**NEW YORK STATE THRUWAY AUTHORITY  
DEPARTMENT OF ENGINEERING**

**AMENDMENT NO. 1  
TO**

**CONTRACT TAA 25-19  
D215042  
2" MILL AND INLAY, SAFETY IMPROVEMENTS  
AND MISCELLANEOUS WORK ON I-87  
BETWEEN MP 76.5 AND MP 86.6  
IN THE ALBANY DIVISION  
OF THE NEW YORK STATE THRUWAY  
IN ULSTER COUNTY**

**IN THE LETTING OF  
DECEMBER 17, 2025**

CONTRACT NUMBER:  
TAA 25-19  
DATE:  
10/20/25  
DRAWING NUMBER:  
ST2-1

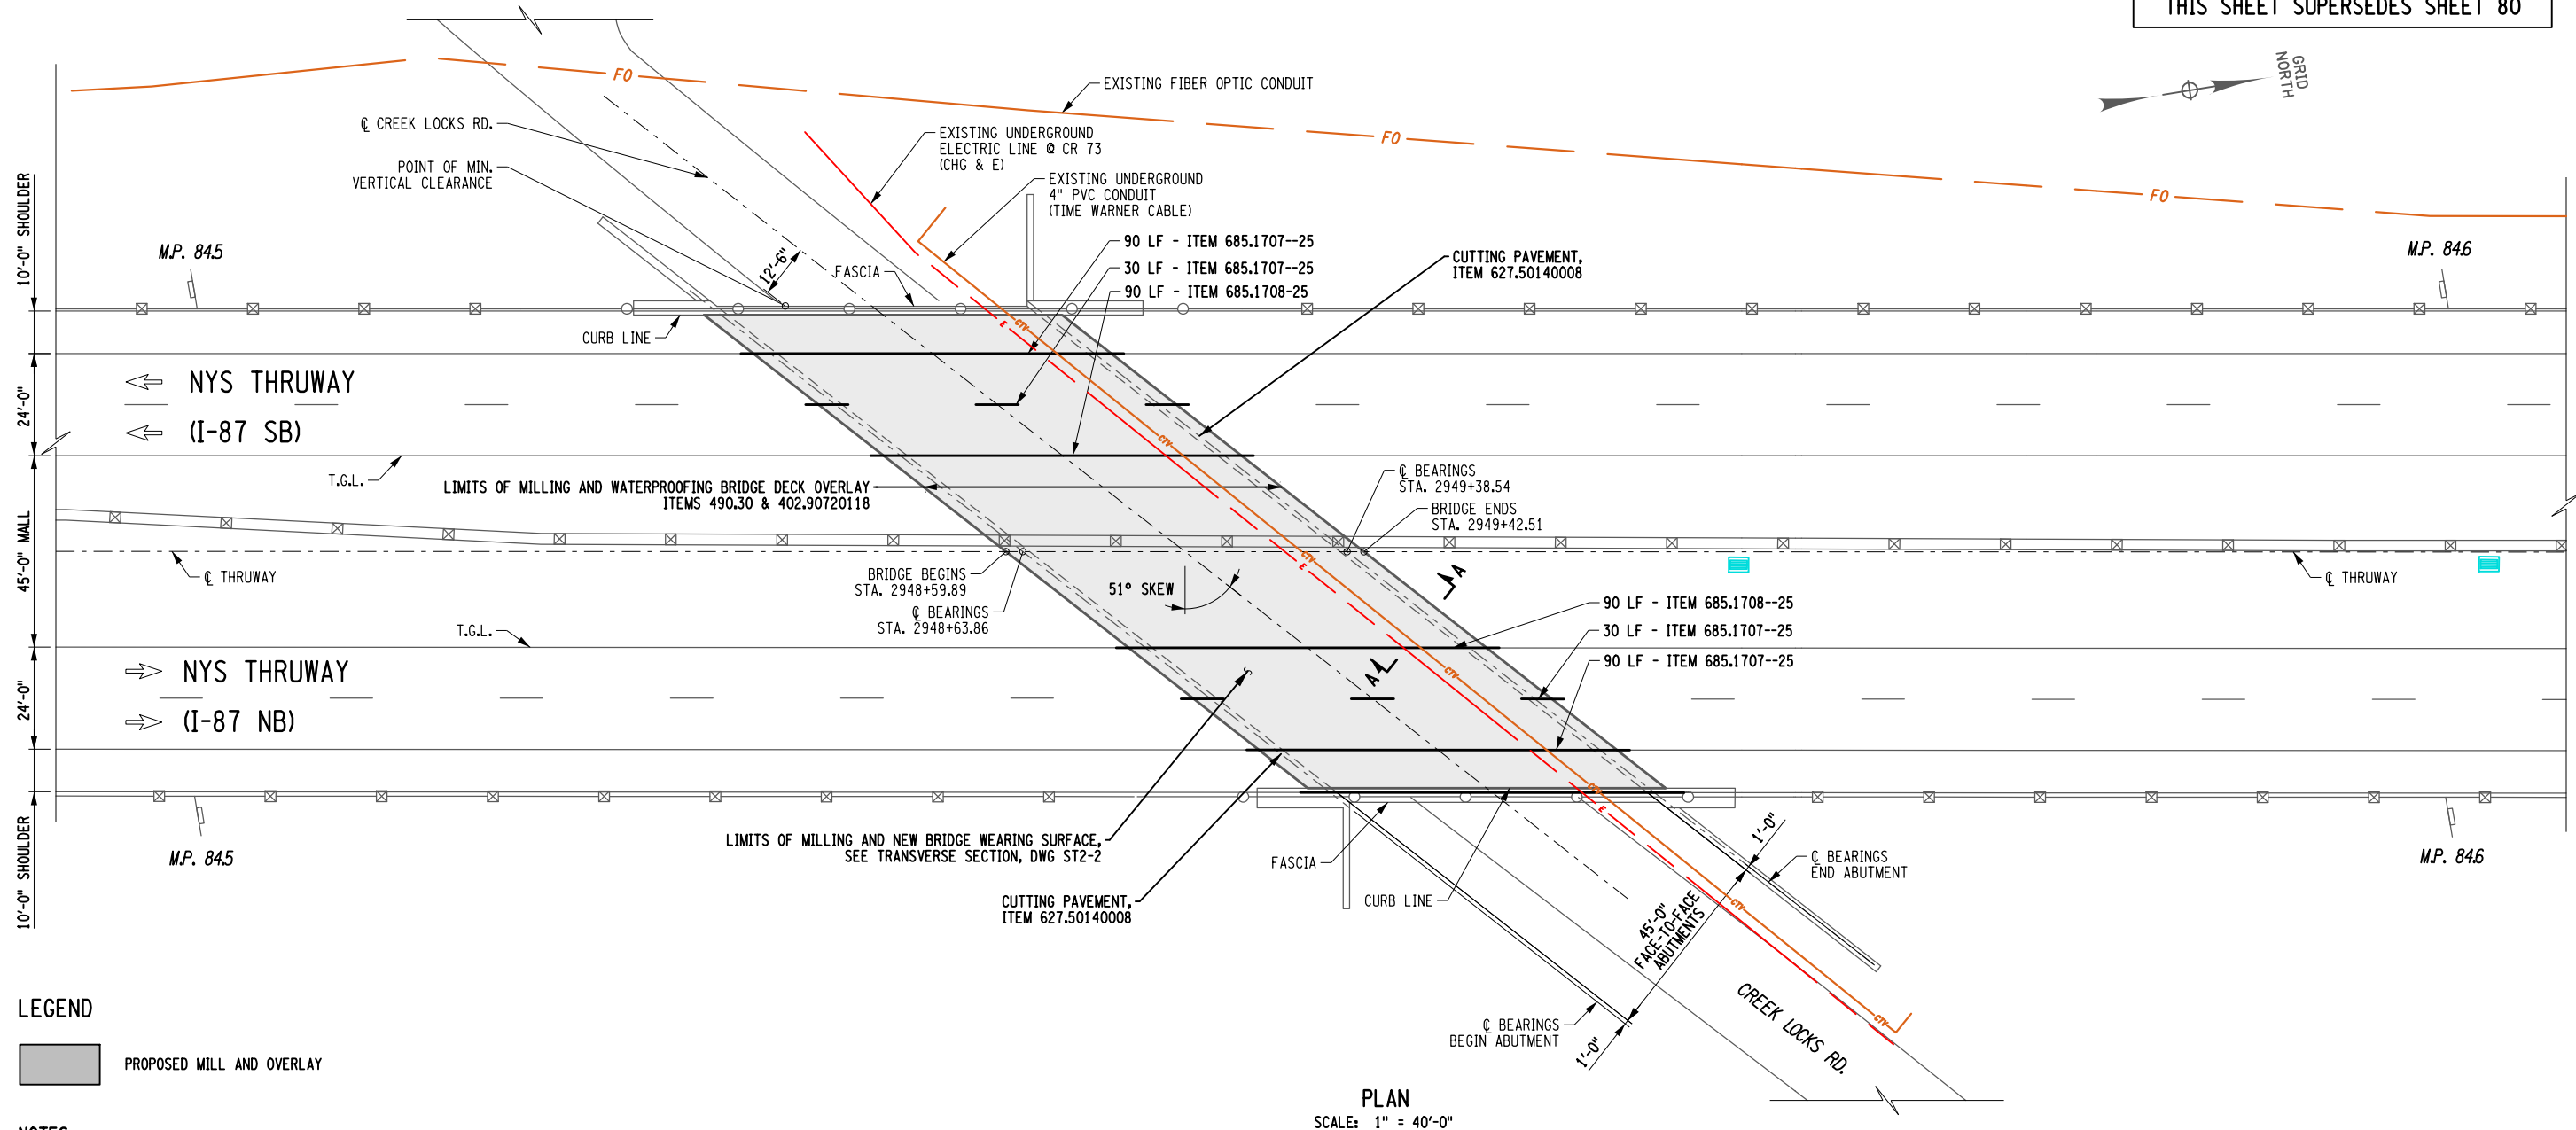
4. **DELETE** Drawing Number ST1-1, Sheet 74 of 81, and **SUBSTITUTE** with the attached Drawing Number ST1-1, Sheet 74-A1 of 81. Reference to Item 567.51000009, Sealing Existing Bridge Joints on the South Abutment has been removed. A new reference to Section A-A and its details have been added.
5. **DELETE** Drawing Number ST2-1, Sheet 80 of 81, and **SUBSTITUTE** with the attached Drawing Number ST2-1, Sheet 80-A1 of 81. References to Item 567.51000009, Sealing Existing Bridge Joints on the south and north abutments have been removed. A new reference to Section A-A and its details have been added.
